## IMPORTANT SAFETY RECALL

EnTrans International DBA Polar Tank Trailer, Heil Trailer International has decided that a defect which relates to motor vehicle safety exists in certain 2017 Polar Tank trailers identified above.

## Circumferential Seam Repair

Repair for cracks developing from partial penetration weld.

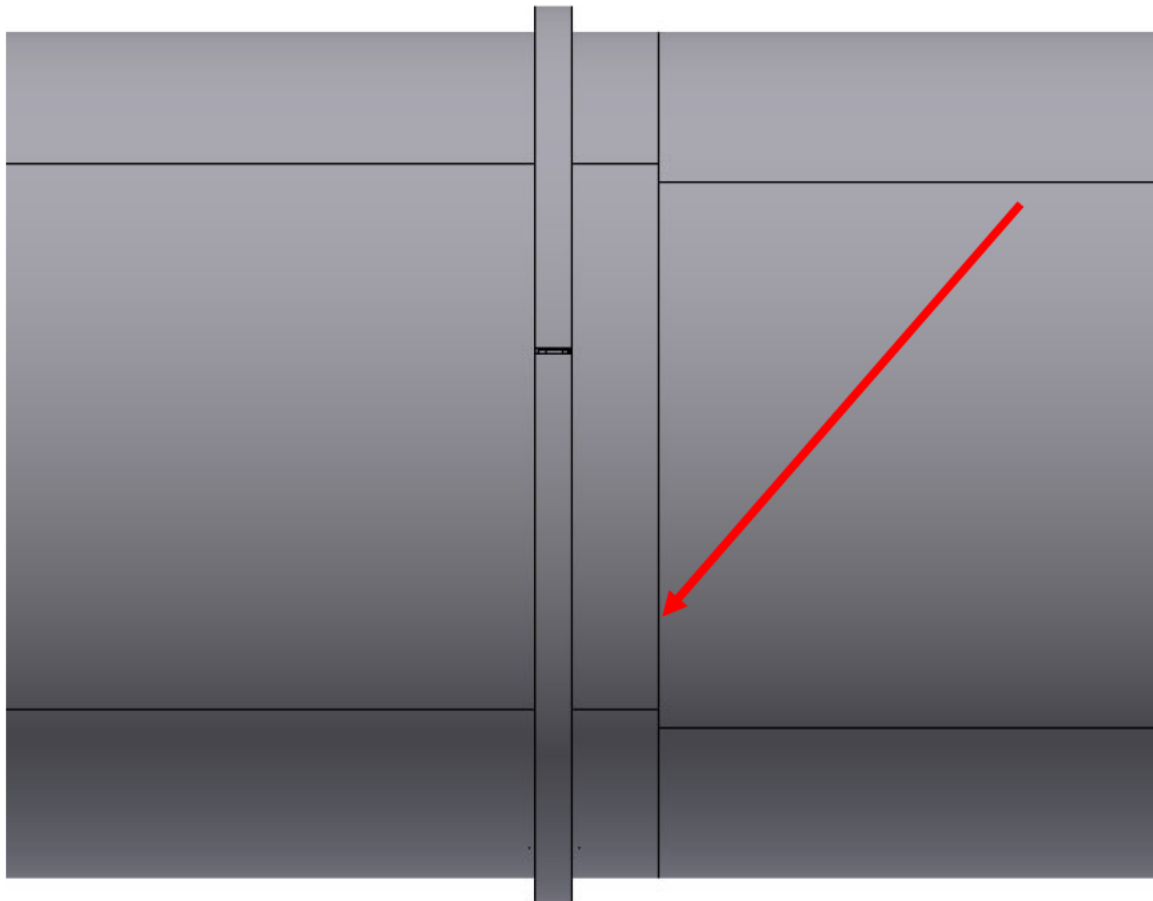
2. Inspect circumferential seam for cracks or any sign of leaking on the bottom half of the tank. If any are found document location, take pictures, and send pictures to Entrans Warranty Department (contact information listed below).

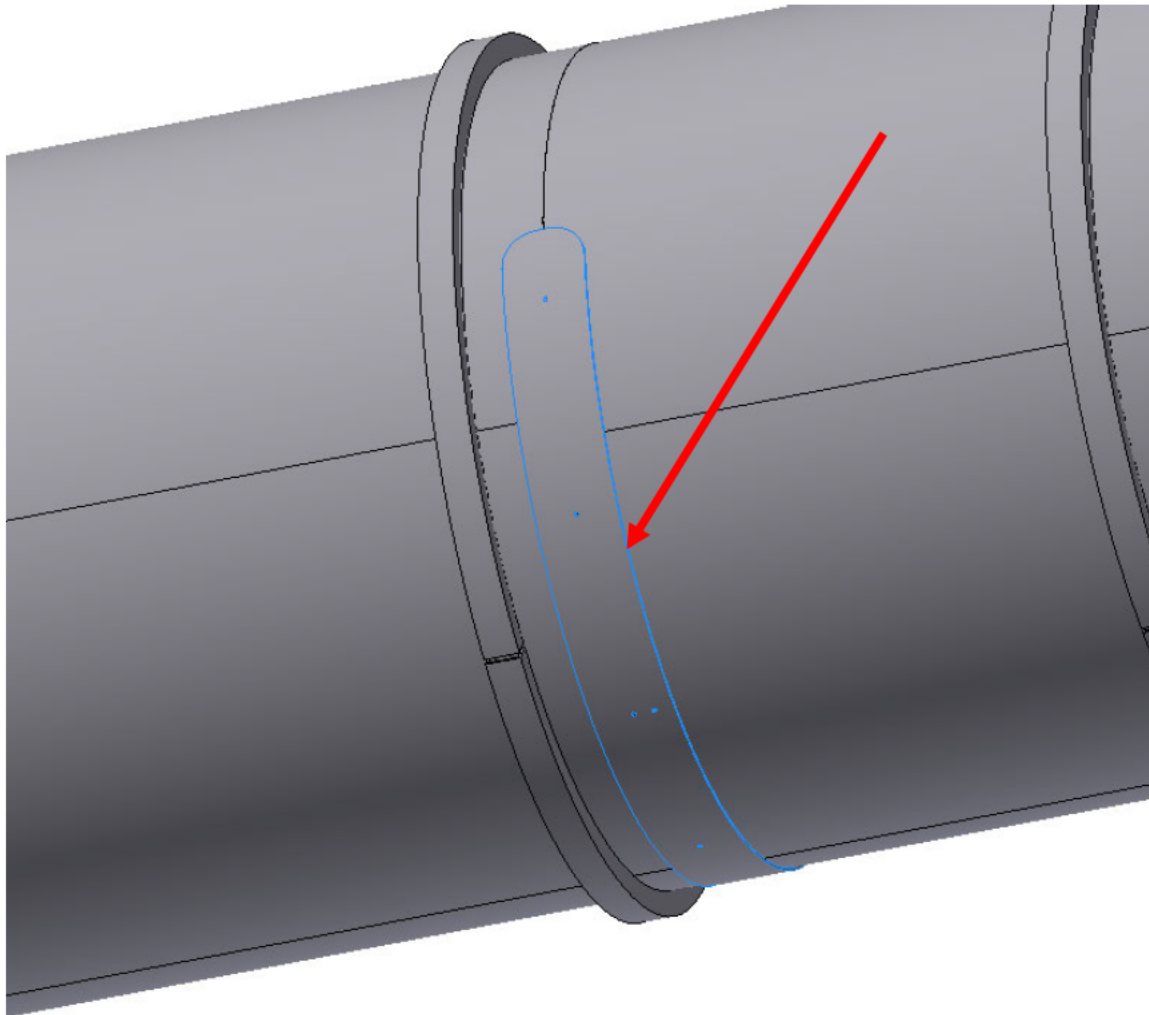
3. Weld in repair pad KM16613 over the circ seam. Repairs to any existing cracks must be completed prior to welding the reinforcing pad in place.
